## MUNICIPALITY OF ANCHORAGE

#### MEMORANDUM

**SUBJECT:** 2017-0055 Context Sensitive Solutions Transportation Project, Plans in Hand Review, 100<sup>th</sup> Avenue Extension Minnesota Drive to C Street – Phase IIB

PROJECT: 100TH AVENUE EXTENSION, PHASE 1B  
 SHEET: 78 OF 84  
 DATE: 1/27/2017  
 SCALE: 1"=20'

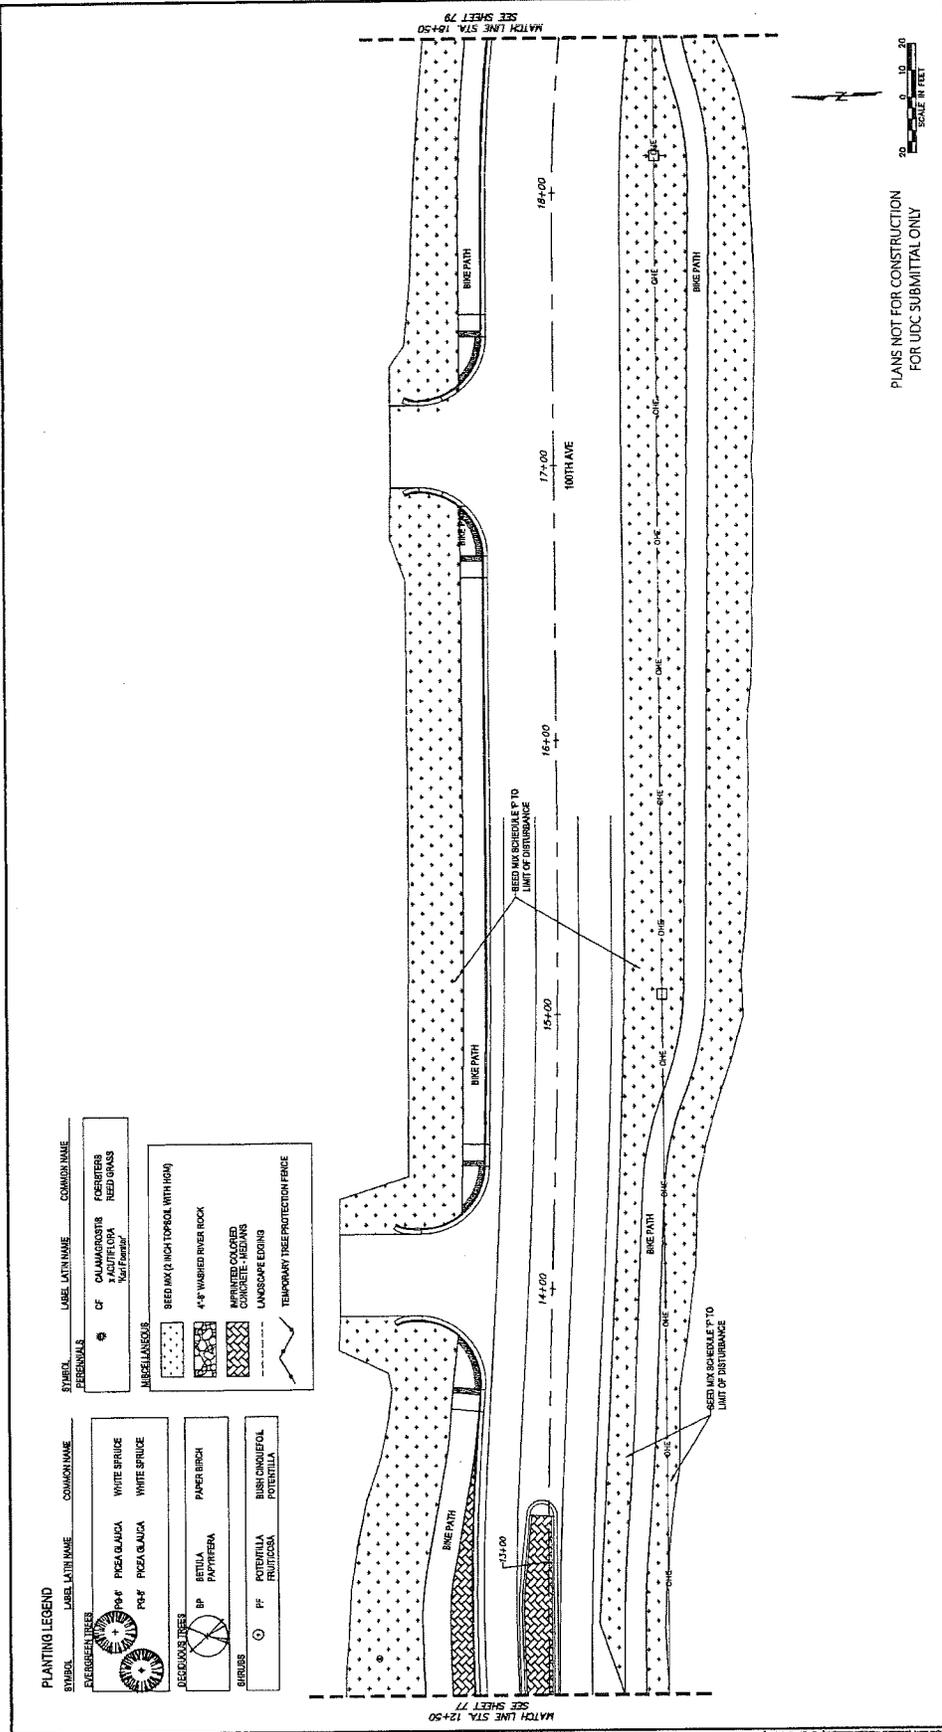
- a. Planting Plan map:
  - i. 100<sup>th</sup> Ave should read W. 100<sup>th</sup> Ave, please correct
- b. Signing, Striping, and Illumination map:
  - i. 100<sup>th</sup> Ave should read W. 100<sup>th</sup> Ave, please correct
- c. Sign Review:
  - i. There was no sheet for sign review on the D3-101 signs, if there is one please forward to addressing for review.

SCALE: 1"=20'  
DATE: 07/2017  
SHEET: 018  
84

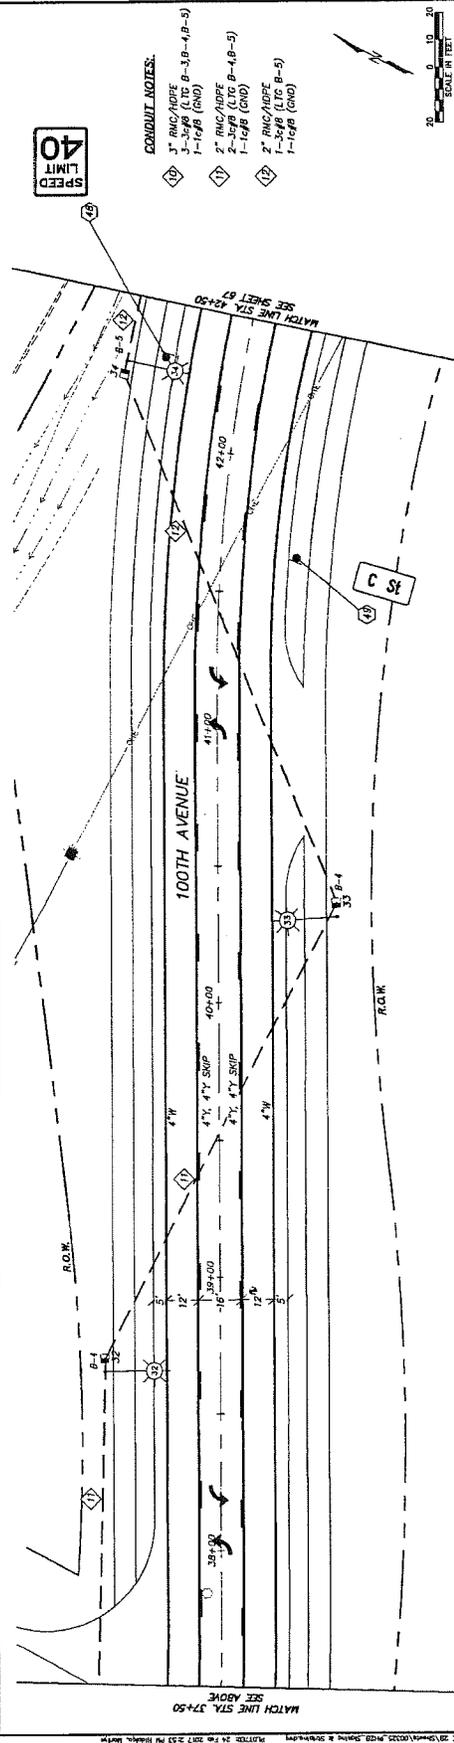
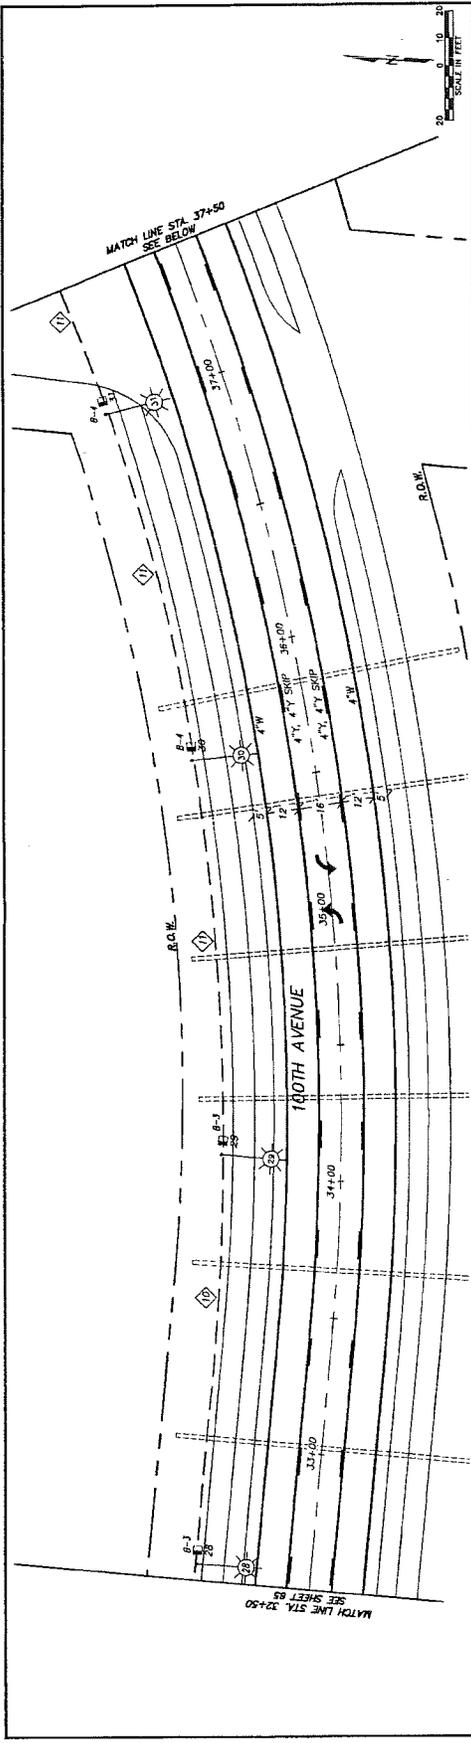
1. Resolve with Traffic the comments regarding improper signage and striping for roundabouts for 100<sup>th</sup> Avenue plan set.
2. Verify that the minimum of 6 foot refuge is provide at all Pedestrian Refuge location for the roundabouts.
3. Verify maximum slope of 2% of all driveway and pedestrian ramp landings. Resolve the use of tactile warnings that are non-compliant with MOA standards and practices.
